NAME OF PROJECT: Oak Run Commercial Unit 9; Located on Loop 337 approximately 700 feet north of State Hwy 46; New Braunfels, Texas

Re: Edwards Aquifer, Comal County
NAME OF PROJECT: Oak Run Commercial Unit 9; Located on Loop 337 approximately 700 feet north of State Hwy 46; New Braunfels, Texas
TYPE: Technical Assistance Regarding a Modification of Water Pollution Abatement Plan (WPAP), 30 Texas Administrative Code (TAC) §213.5(b)
Edwards Aquifer Protection Program File No. 1605.02

Re: Oak Run Commercial Unit-9 Water Pollution Abatement Plan
TNRCC Project No. 1605.00
Technical Letter – Relocation of Basin A

OAK RUN COMMERCIAL UNIT-9
PERMANENT POLLUTION ABATEMENT PLAN

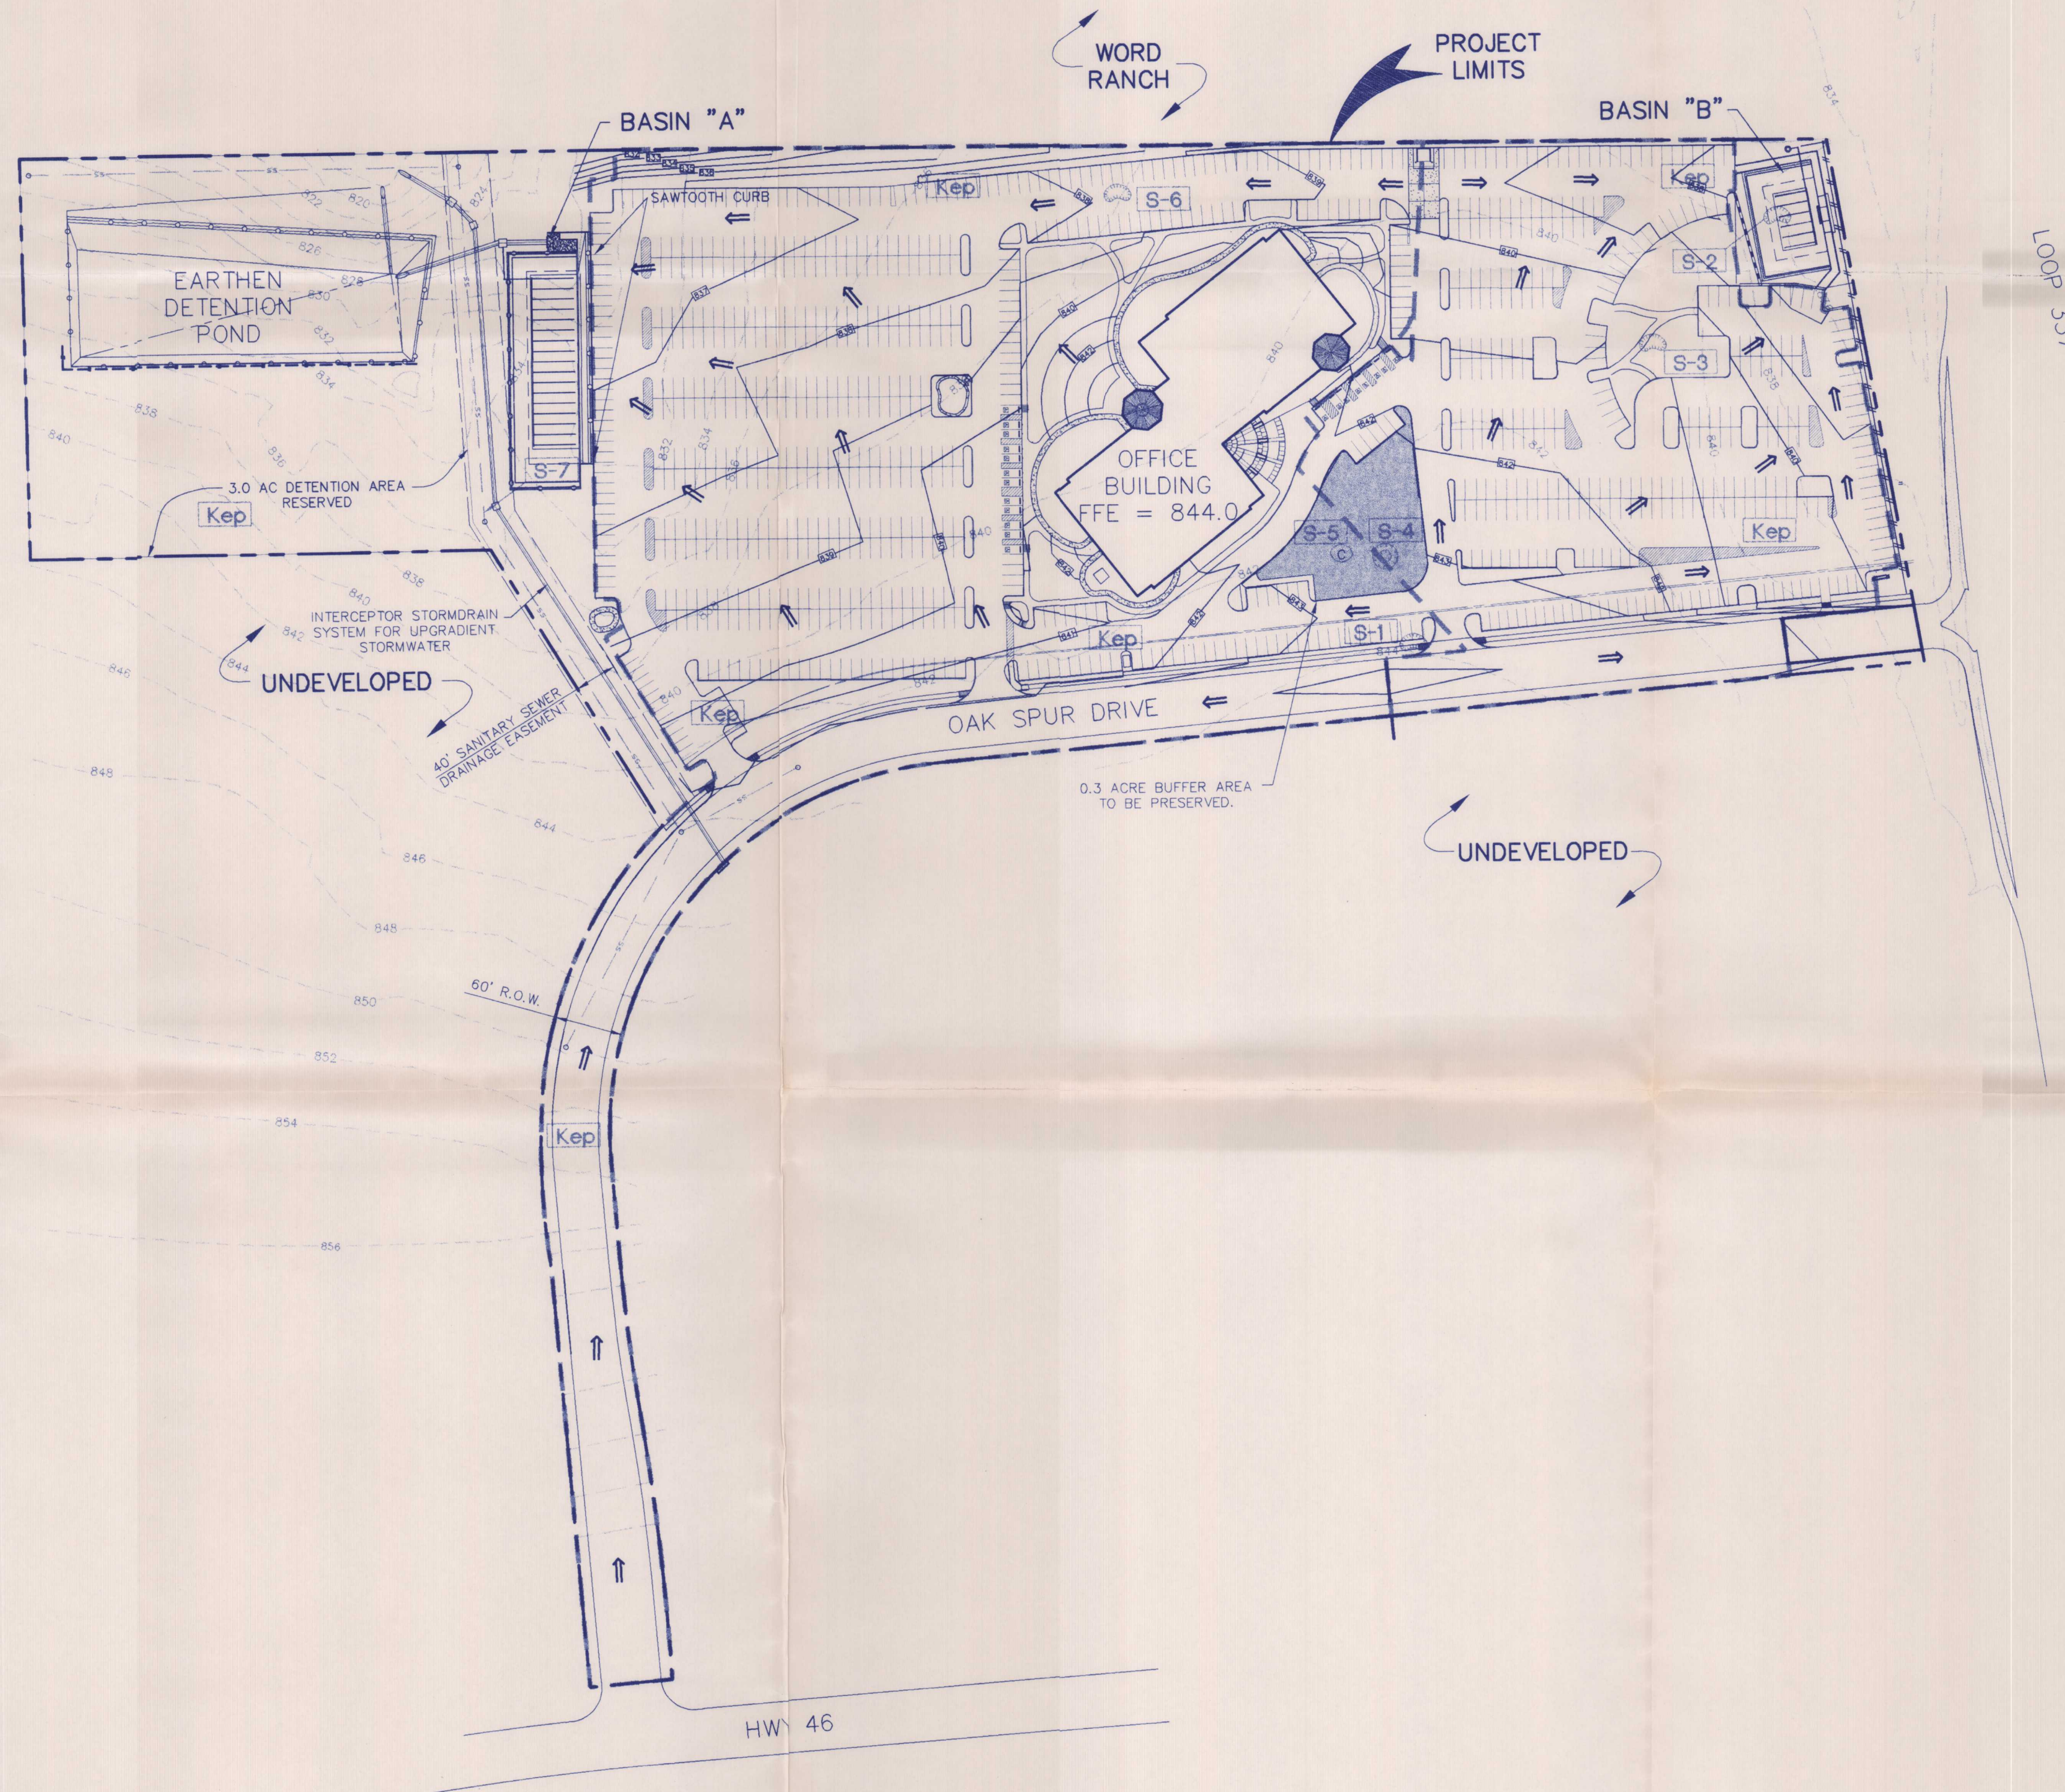
- Revisions to the parking area on the north and west areas of the site due to the elimination of the retaining wall
- Revisions to the grading and sidewalks around office building
- Basin A was relocated approximately 67 feet to the southwest to accommodate the grading revisions and retaining wall removal.
- The basin release pipe will tie into an underground storm drain system leading to the proposed detention basin instead of the open channel previously shown. (This revision does not impact the design of the sedimentation/filtration basin.)
- The basin overflow will be directed to an underground storm drain system leading to the proposed detention basin. The decision to switch from an open earthen channel

REVISIONS:
5/7/01 BASIN "A" LOCATION MOVED
